**RE: MERIDIAN ENERGY LIMITED – APP.045356.01.01 – LU2300093 – RFI RESPONSE No #4**

The following is a final response to items 2 (NRC), 5 (WDC), 7 (WDC), and 9 (WDC), together with a summary of all responses to the WDC components of the RFI dated 3 October 2023.

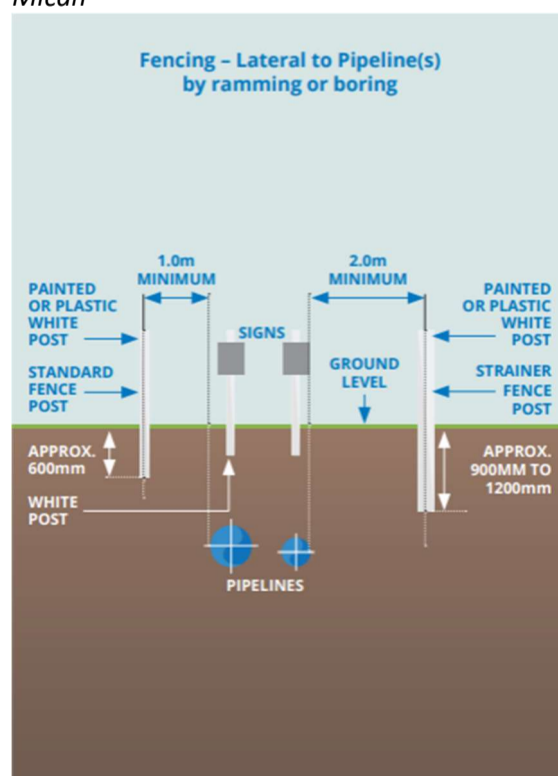
1. the concept planting plan for our western border (where the RAP exits the site – pg2 of the attached). We have taken Firstgas's planting guidelines and applied it to this border. – *Subject to further assessment at detailed design stage, FGL is satisfied that what is suggested in your email of 25 October, meets our requirements with respect to planting in the NW corner of Site 3.*
2. On the Northern border of site 3 (where the RAP enters the site – pg 1) we are now planning to use a synthetic screen rather than screen plantings. This synthetic screen will need to traverse the RAP designation.
3. Aside from this synthetic screen across the Northern border. We plan on putting a security fence around the whole of the site.

Given items 2 and 3 above, does Firstgas have guidelines on fencing within the RAP designation that you can share? – *Below is some direction taken from our 'Easement Working Practices Guideline' with regards to fencing within the easement corridor. This gives an indication of our expectations, the separation and the signage required. As you would expect for any work of this nature within the easement corridor, a permit and a stand-over would be necessary.*

Ultimately, as previous agreed, we are happy to engage with Firstgas during our detailed design phase to ensure the solar farm, screen plantings, and fencing meets Firstgas requirements. At this stage we are just hoping that Firstgas can provide approval (in principle) for our planting and screening plans as attached or indicate if there are any concerns that would be unworkable. The goal being to provide council with a response that indicates that Firstgas is aware of Meridian's screening concept and is happy in principle but further engagement will be required during detailed design. *Based on the level of information provided to date, Firstgas is happy to provide support in principle, subject to further assessment at detailed design stage.*
